W3F1-2001-0007  
A4.05  
PR

Subject: Waterford 3 SES  
Docket No. 50-382  
License No. NPF-38  
Request for Review and Approval of Design Basis Change Regarding  
Realignment of Refueling Water Storage Pool (RWSP) Boundary  
Isolation Valves to RWSP Purification System

**Marked-Up UFSAR Pages**

TABLE 3.9-9 (Sheet 12 of 22) Revision 10 (10/99)

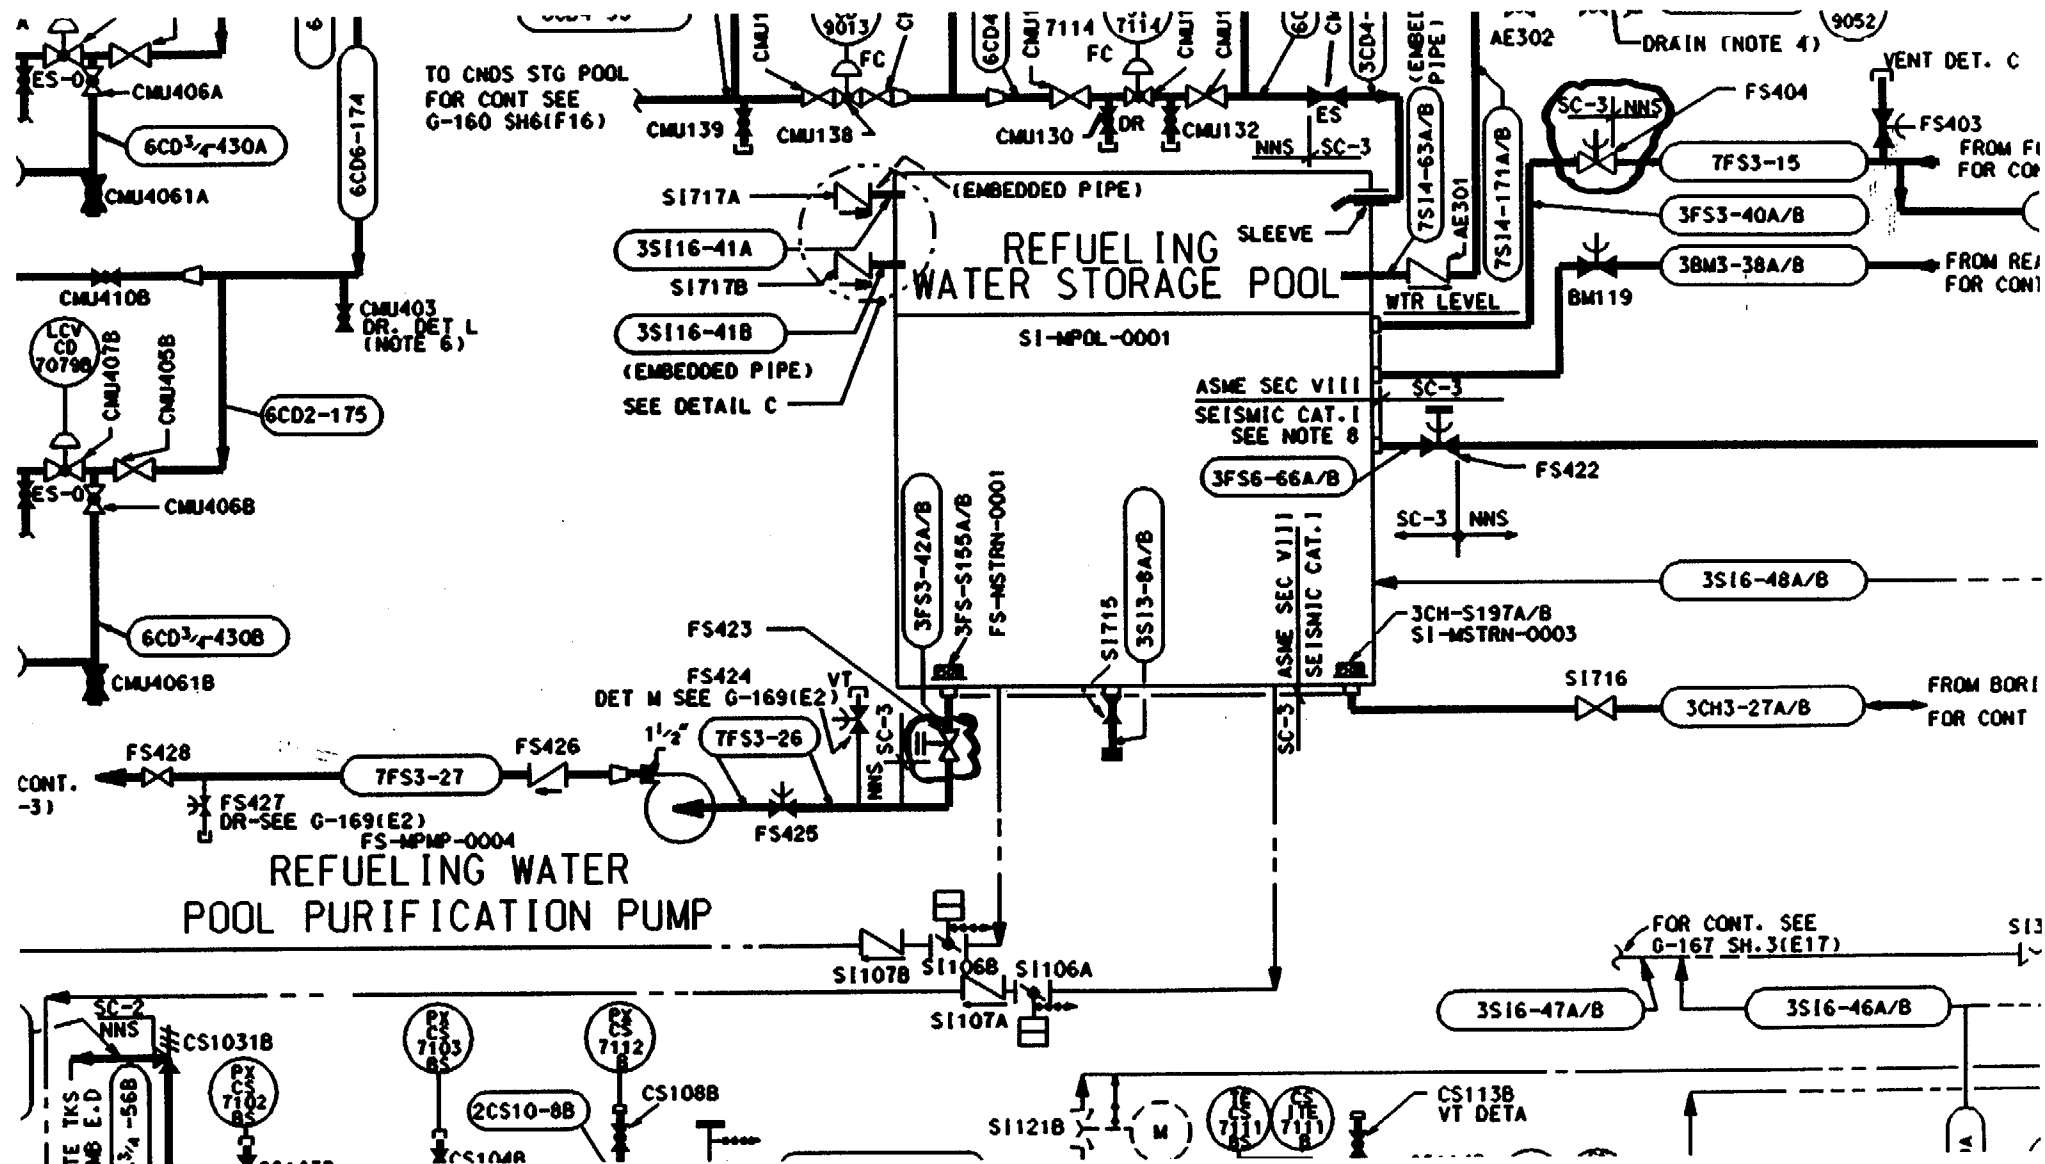
ADD INSERT No. 1

<u>Equipment</u>	<u>Tag No.</u>	<u>Ebasco No.</u>	<u>Quantity</u>	<u>Type</u>	<u>Operator</u>	<u>Manufacturer</u>	<u>Safety Class</u>	<u>Design Rating</u>	<u>Size</u>	<u>Function</u>
<u>Fuel Pool Cooling &amp; Purification (FS)</u>										
RWSP Purification Pump Suction Isol. From RWSP	FSMVAAA423	3FS-V135A/B	1	Gate	Manual	Anchor Darling Valve Co.	3	50 psig 125 °F	3"	Close
Fuel Pool Ion Exchanger to RWSP Isolation	FSMVAAA404	3FS-V123	1	Diaphragm	Manual	ITT Grinnell	3	150 psig 200 °F	3"	Close
